SUBJECT: Transmittal of Responses to AP1000 DSER Open Items

**AP1000 Design Certification Review
Draft Safety Evaluation Report Open Item Non-Proprietary Responses**

DSER Open Item Number: 3.7.2.3-1 (Revision 1)

Figure 3.8.5.4-1-3
Reaction Forces for DL + SSE (EW being the predominant load, Alpha=1.0)

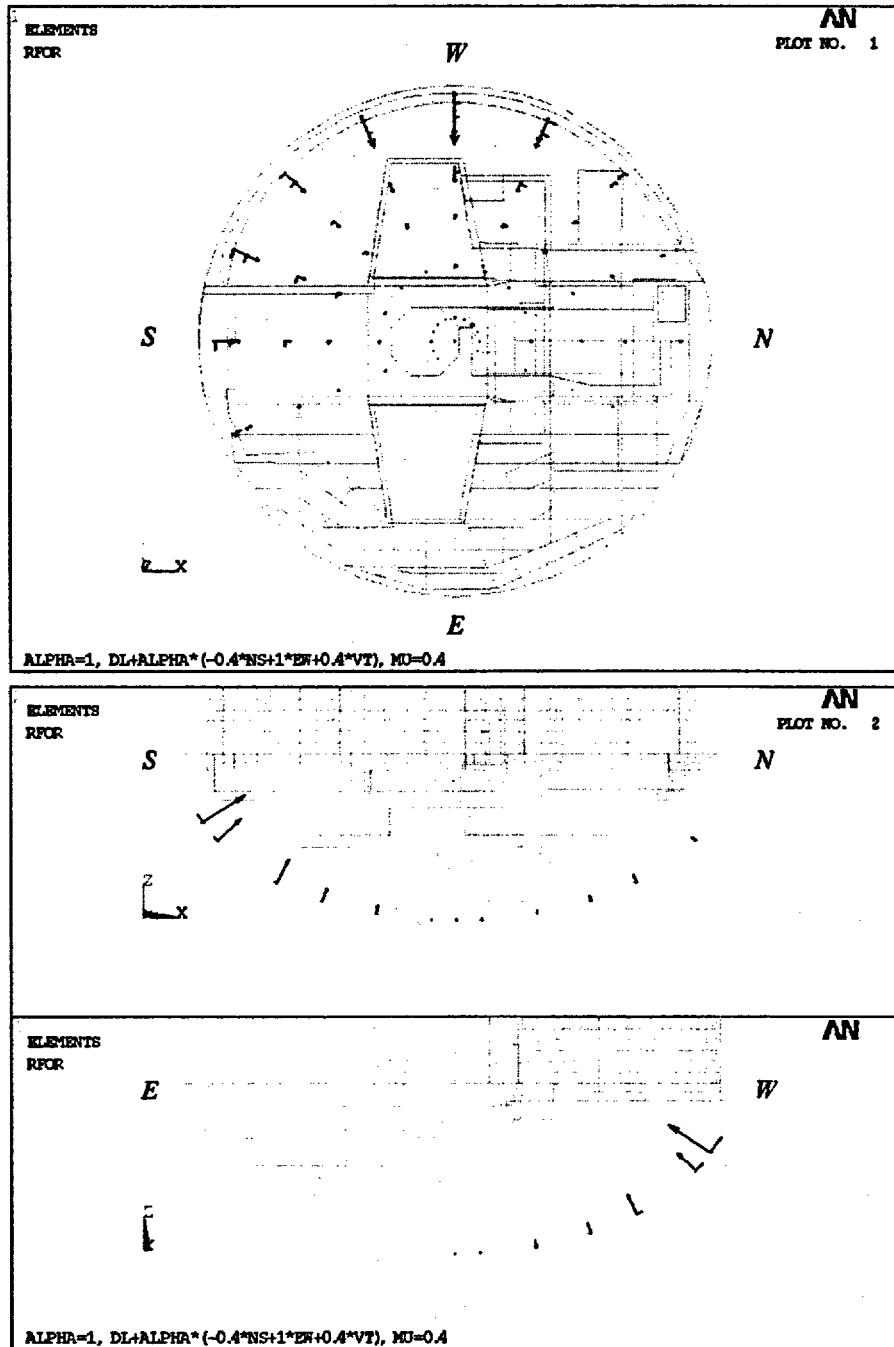
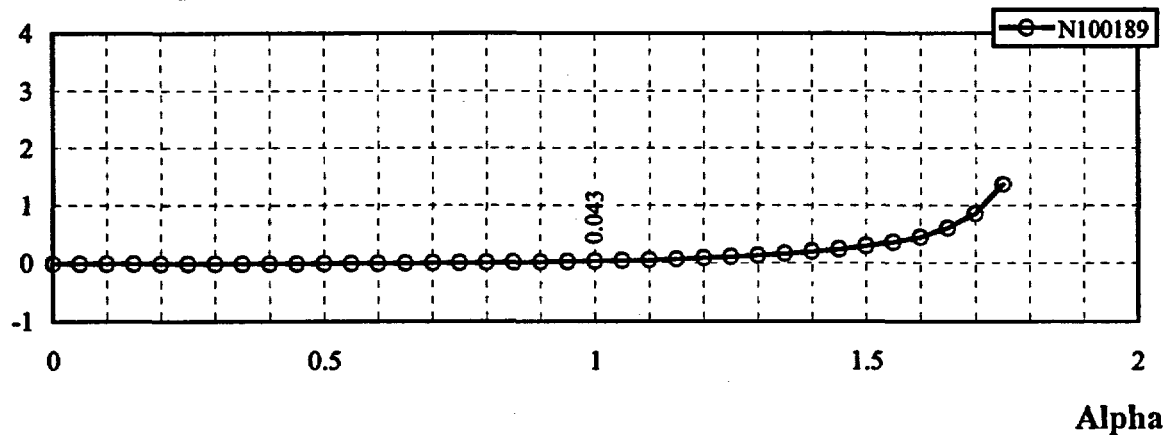
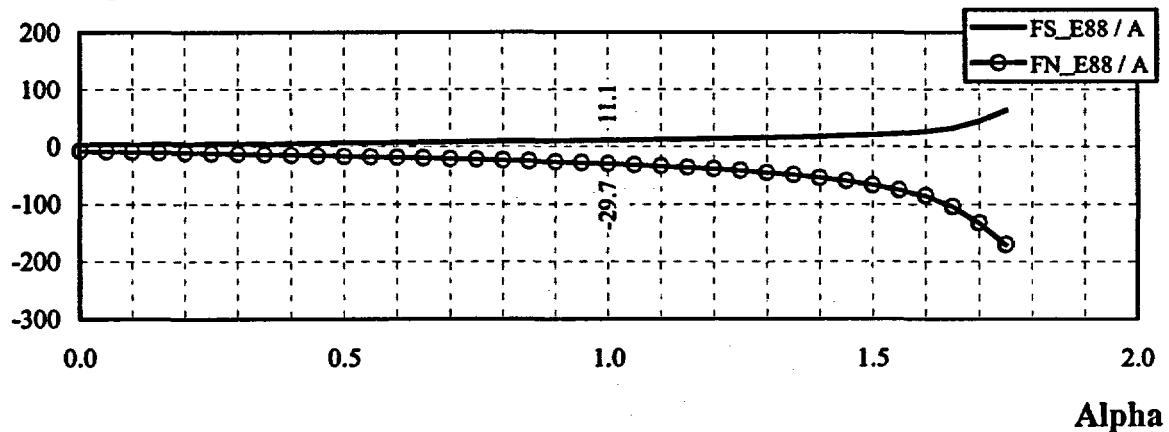
In its review of DCD Tier 2 Section 3.8.5.4, the staff determined that the potential uplift and slapping back of the containment internal structures foundation on the basemat through the steel containment vessel during a seismic event could affect both the seismic design loads and in structure response spectra for all structures, systems and components associated with the containment internal structure, and could also affect the seismic response of the steel containment shell. In RAI 220.021, the staff requested the applicant to perform additional analyses to demonstrate how the uplifting effect will be addressed, and how the uplifting effect on the seismic analysis results will be used for the design of the containment and containment internal structures. This is Open Item 3.8.5.4-1.

Results for the DL combined with SSE where the EW seismic is the predominant load ($-0.4\text{NS} + 1.0\text{EW} + 1.0\text{VT}$) are shown in Figures 3.8.5.4-1-3 and 3.8.5.4-1-4. Cases where either NS or VT SSE are the predominant loads were also analyzed and show similar results. Figure 3.8.5.4-1-3 shows the vertical displacement at the edge of the containment internal structures where lift-off is maximum. Figure 3.8.5.4-1-4 shows the normal bearing reaction and the sliding reaction at the location of the maximum bearing reaction.

The ANSYS results confirm the hand calculation conclusions, the separation between containment internal structures and the basemat during a seismic event is small, and thus would not have a significant effect on the seismic design loads or the in-structure response spectra.
